RE: Willow Pass Generating Station
Application for Certification 08-AFC-06

AFC SUPPLEMENT

In Response to CEC Data Adequacy Review

Application for Certification (08-AFC-06) for WILLOW PASS GENERATING STATION Pittsburg, California

FIGURE 2.5-4 (REVISED)

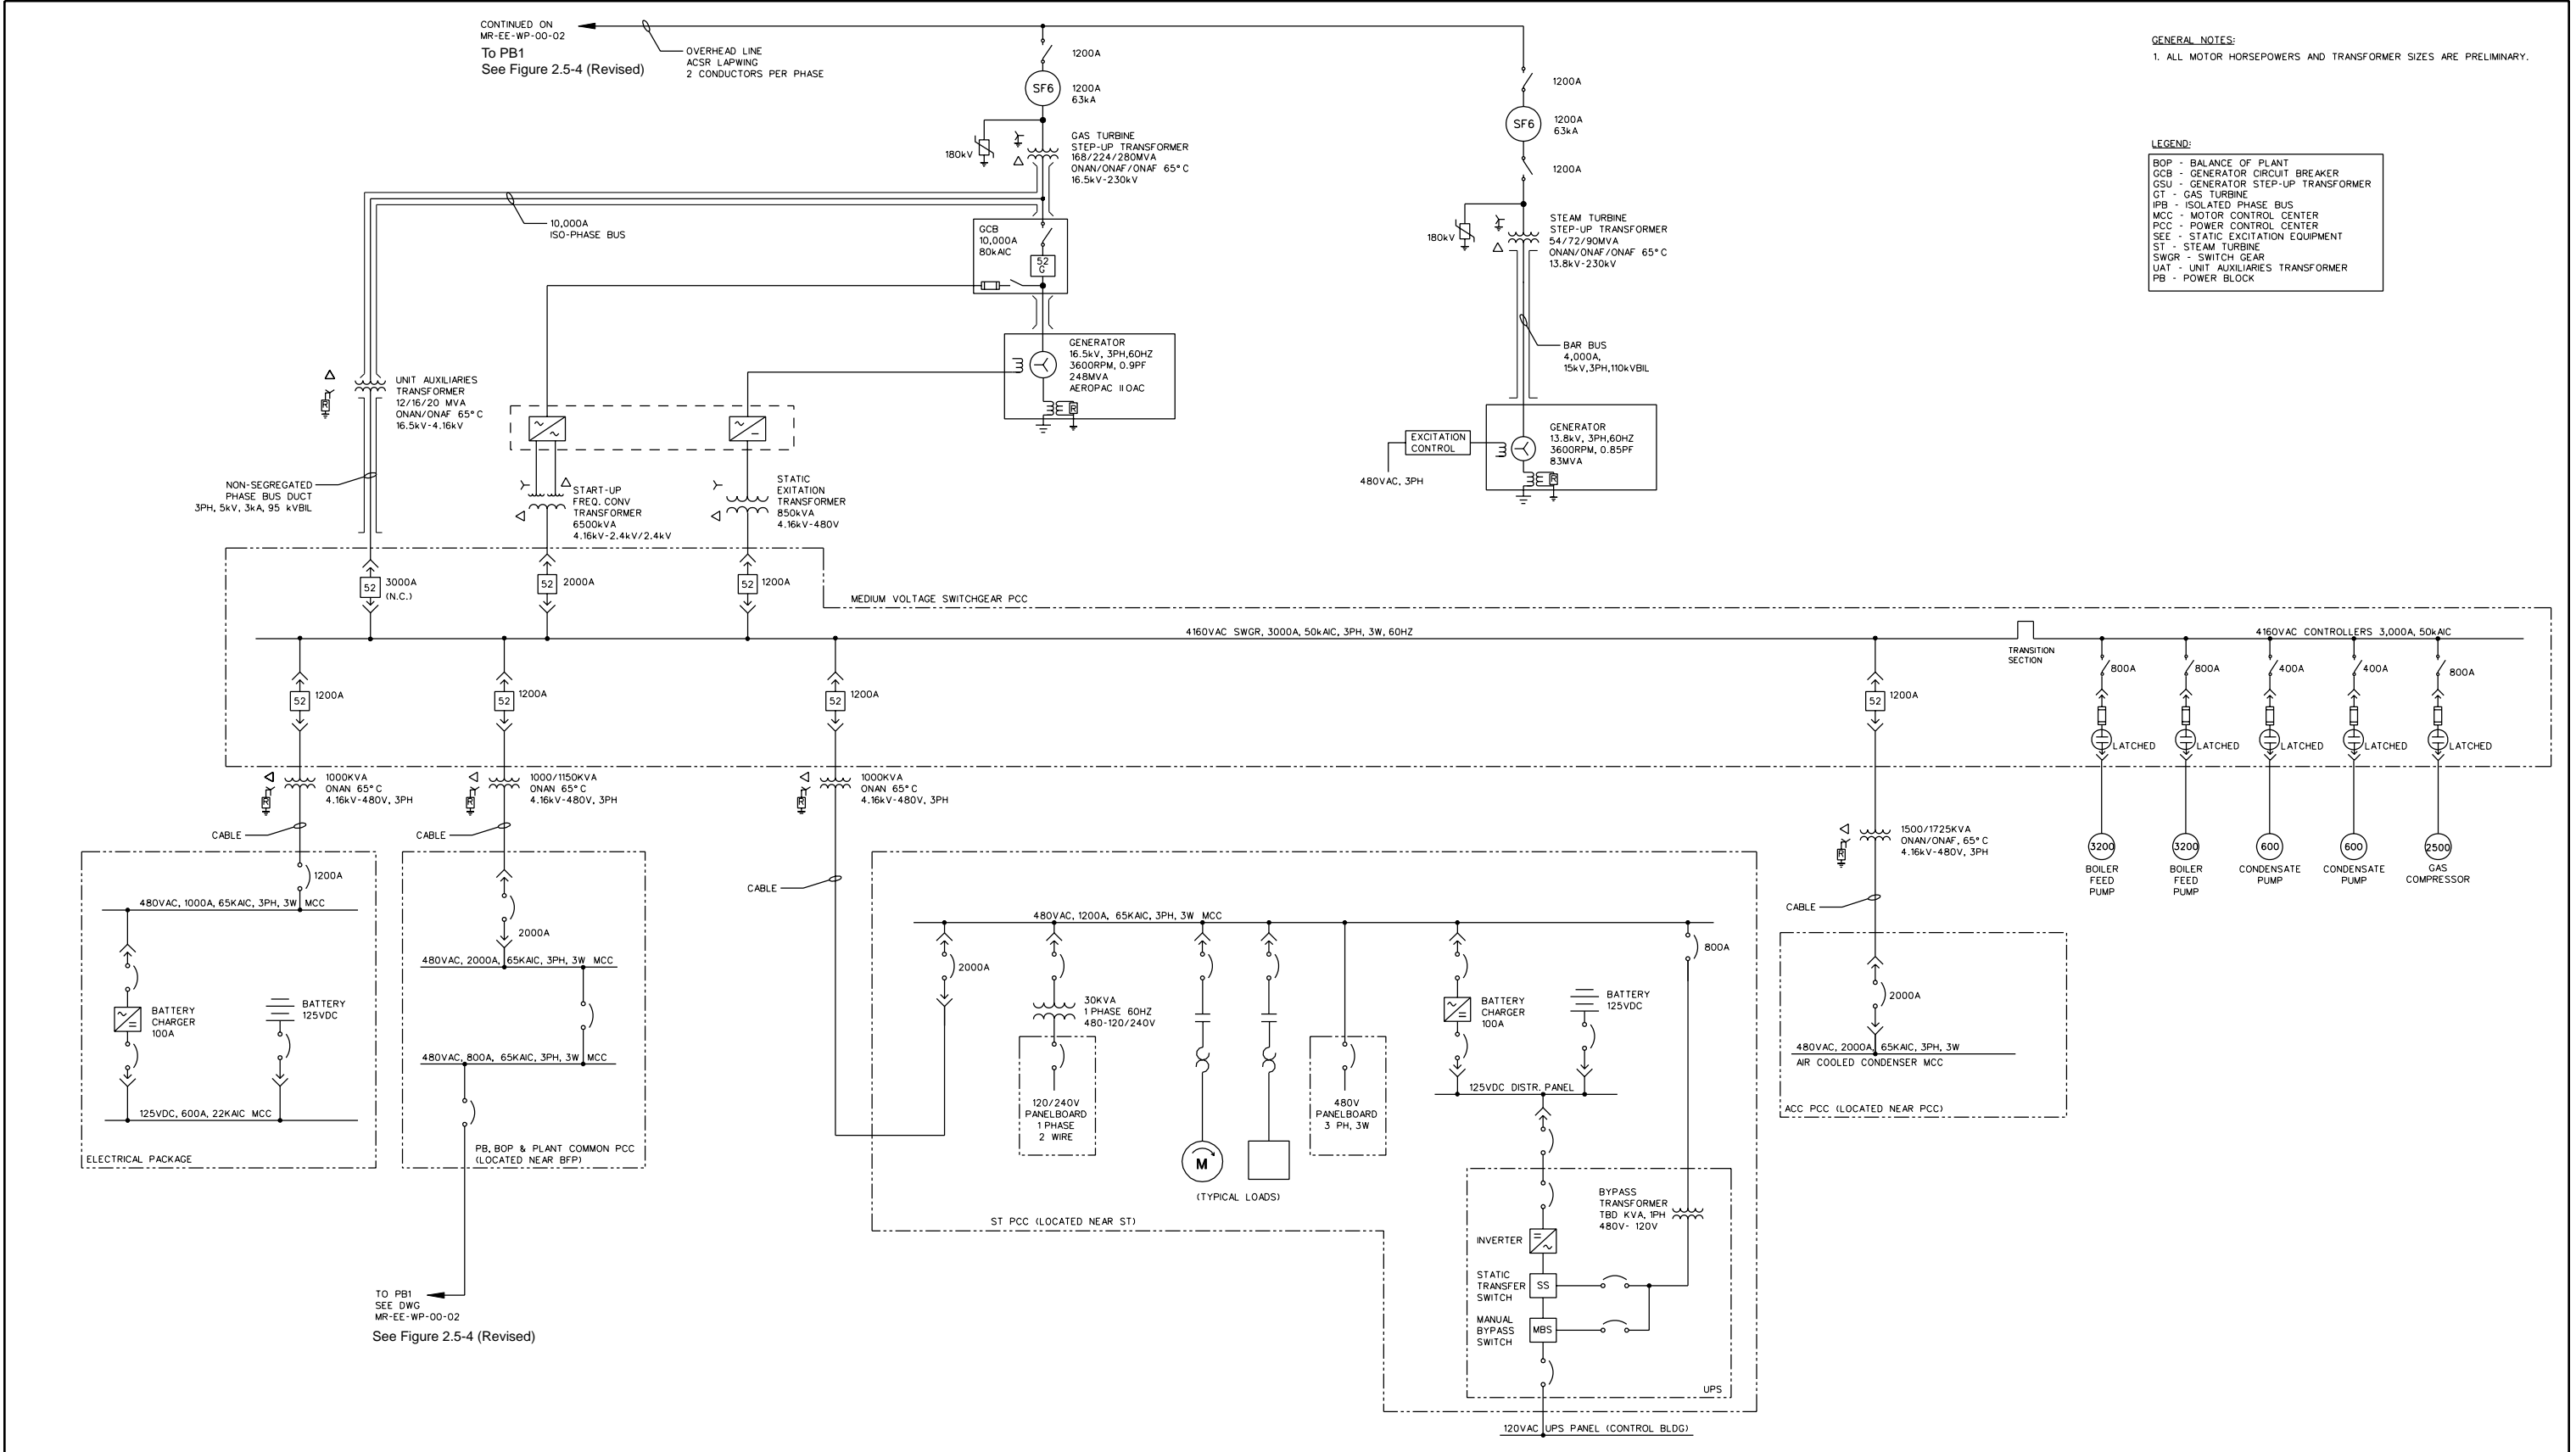
ID	SITING REGULATIONS	INFORMATION	INFORMATION REQUIRED TO MAKE AFC CONFORM WITH REGULATIONS	RESPONSE
13	Appendix B (b) (2) (C)	A detailed description of the design, construction, and operation of any electric transmission facilities, such as power lines, substations, switchyards, or other transmission equipment, which will be constructed or modified to transmit electrical power from the proposed power plant to the load centers to be served by the facility. Such description shall include the width of rights of way and the physical and electrical characteristics of electrical transmission facilities such as towers, conductors, and insulators.	<p>Please provide a complete electrical one-line diagram (or resubmit Figure 2.5-4) of the proposed WPGS 230 kV switchyard showing all equipment for all new generators' interconnection with the switchyard including any bus duct connectors or cables, 13.8/16.5 kV switchgear & breakers on the low side, generator step-up transformers, short overhead conductors and/or cables from the transformers to the switchyard with the configurations for buses, breakers, disconnect switches on the 230 kV side, and their respective sizes and/or ratings, along with the proposed transmission outlet from the switchyard.</p> <p>Please provide a one-line electrical diagram showing the pre-project Pittsburgh Power Plant PG&E 230 kV switchyard with existing generator units and transmission outlets with the configuration for buses, breakers and disconnect switches and their respective ratings.</p> <p>Also, please provide a one-line electrical diagram showing the post-project Pittsburgh Power Plant PG&E 230 kV switchyard with the proposed 230 kV tie line interconnection facilities for buses, breakers and disconnect switches and their respective ratings.</p> <p>Please provide physical layout drawings of the pre and post-project Pittsburgh Power Plant Switchyard showing all major equipment and transmission outlets.</p>	<p>Please see Appendix F1, Figure 2.5-4 (Revised) and Figure F-1, which provide single line diagrams for Power Blocks 1 and 2. In addition, Figure F-2 provides the overall plant single line diagram and Figure F-3 shows the transmission outlet.</p> <p>Please see Appendix F1, Figure F-4</p> <p>Please see Appendix F1, Figure F-3</p> <p>Please see Appendix F1, Figure F-5, which shows the pre-project Pittsburgh Power Plant layout. Also see Figure 4-1 (Revised), which shows the WPGS and PG&E switchyard layout. No additional modifications will need to be made to the existing switchyard.</p>
